SERVICE LETTER

No. 596A

Piper Aircraft Corporation

Subject: Nose Landing Gear System Product Advancement Information.

NOSE GEAR STRUT ASSEMBLY

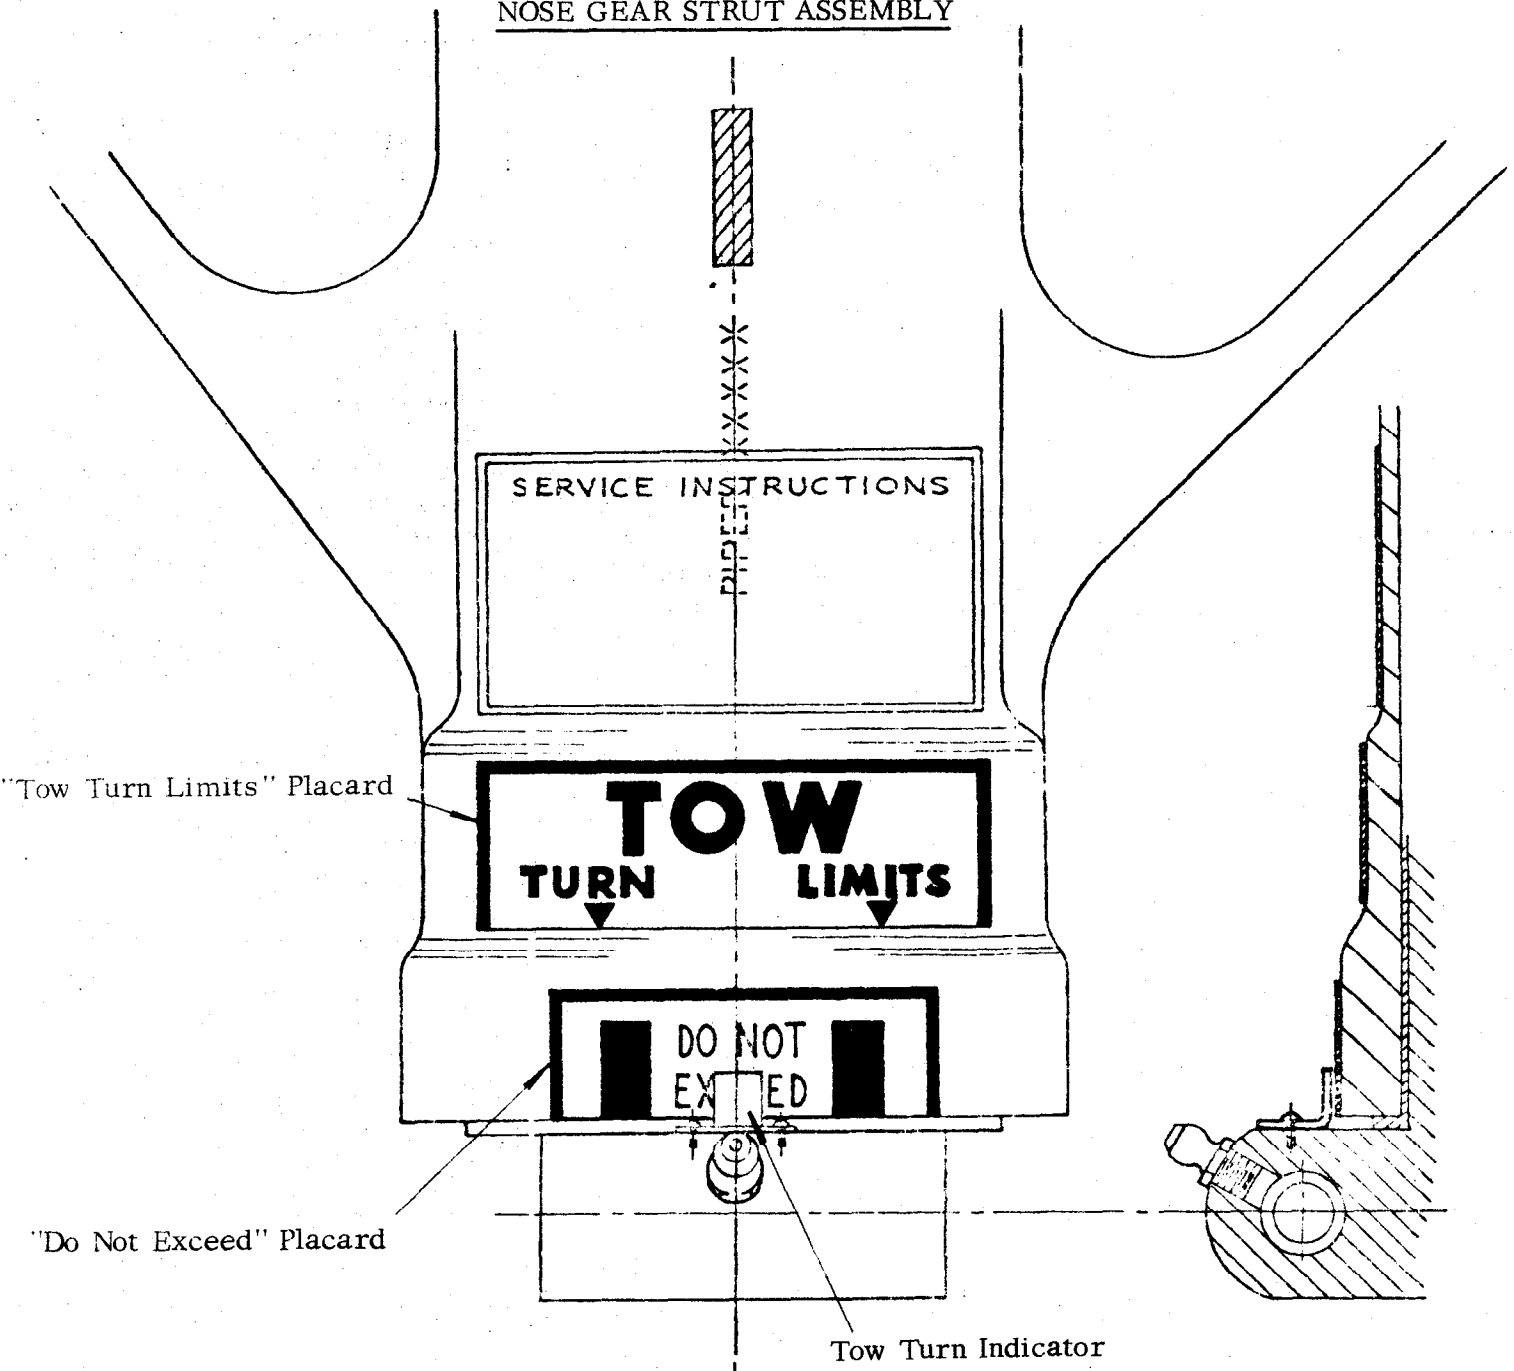
Safety Wire

Drill and Ream Holes
.202
.204 Diameter

Replace Existing Bolts with
High Strength Bolts - P/N 402 800
(NAS 1303-8H) (3 Req'd.)
Torque 30-35 in. lbs.

1. Nose Gear Aligner Guide Bracket Assembly - applies to all aircraft specified in Material Required No. 1, below:
 - a. Inspect existing Nose Gear Aligner Guide Bracket; if guide channel material thickness is .062", replace with new Aligner Guide Bracket Assembly, part number 21719-11. NOTE: It is recommended that the new Aligner Guide Bracket be installed using the new "High Strength" Attachment Bolts, specified below. Prior to installation, check attachment bolt hole size (in Aligner Guide Bracket) to insure .202" diameter, as shown on top portion of attached sketch. .204

- b. If existing Aligner Guide Bracket channel material thickness is .095", remove, ream attachment bolt hole size to .202" diameter (as shown on top portion of attached sketch) .204 and reinstall using new "High Strength" bolts.

- (1.) PA-24-260, serial numbers 24-4980 to 24-4983 inclusive, 24-4985, 24-4986, 24-4988 to 24-5047 inclusive.
 - (2.) PA-39, serial numbers 39-114 to 39-117 inclusive, 39-119 to 39-121 inclusive, and 39-123 to 39-127 inclusive, 39-129 and 39-131.
 Remove the Aligner Guide Bracket Assembly, ream attachment bolt hole size to .202" diameter, and reinstall using "High Strength" attachment bolts. .204
